11. COA-079739-2020

2006-2008 Venable Street

Commission of Architectural Review

STAFF REPORT

Figure 1. 2006-2008 Venable Street, façade

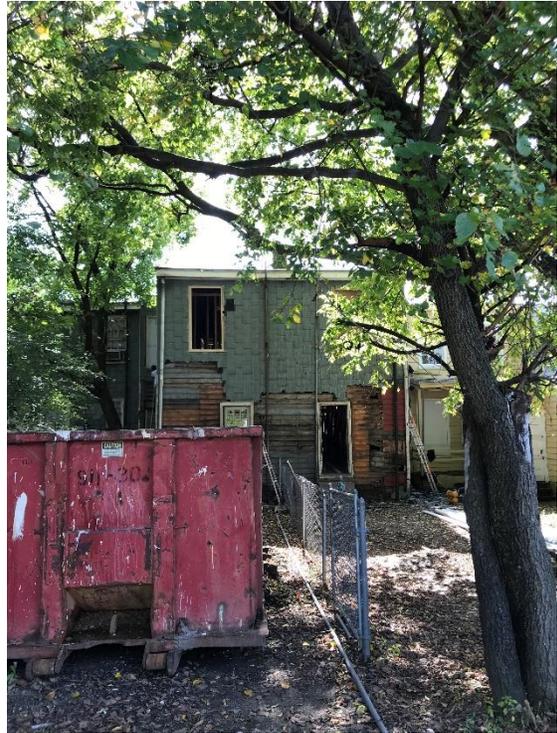
- Any replacement of the cornice elements be done in-kind with wood to match the existing design and profile.
- The wood siding be consolidated on the façade and if any additional siding is needed it be wood siding with a reveal to match the historic reveal.
- The fiber cement siding on the rear of the building be smooth and unbeaded.
- One paint color be used for the entire building and be submitted to staff for administrative approval.
- The front porch roof be replaced with TPO in a dark color.
- Any existing box gutters be retained and repaired and specifications for any new gutters be submitted to staff for administrative approval.
- The composite decking be tongue-and-groove and be installed perpendicular to the façade.

- The replacement railing be a hand-sawn design to match the historic photograph, and revised drawings be submitted for administrative approval.
- The second story façade windows fit within the historic openings and be replaced with 2/2 wood or aluminum clad wood windows with simulated divided lights with interior and exterior muntins and spacer bars between the glass.

- The first story façade windows be retained and repaired.
- The front doors be retained. If they are beyond repair, evidence be submitted to staff and the new doors match the existing design.

<p>The plans also indicate that new front doors will be installed. The existing front doors are identical designs that closely match the front doors at 2010-2012 Venable Street. <u>Staff recommends the front doors be retained. If they are beyond repair, staff recommends the new doors match the existing design and specifications be submitted to staff for administrative approval.</u></p>
<p>Windows, pg. 69</p>	<p><i>7. Windows should only be replaced when they are missing or beyond repair. Any reconstruction should be based on physical evidence or photo documentation.</i></p> <p><i>8. The number, location, size or glazing pattern of windows should not be changed by cutting new openings, blocking out windows or by installing replacement sash that do not fit the original window. Changes to existing windows or the addition of new windows along a secondary elevation will be considered by the Commission on a case-by-case basis.</i></p>	<p>The plans and project narrative indicate that all windows will be replaced with new wood windows. Staff also notes that many of the wood windows have already been removed by the applicant. Photographs submitted by the applicant indicate that several of the window sashes are missing, and based on photographic evidence some of the windows have been replaced. Staff also notes that many of the windows have already been removed by the applicant.</p>
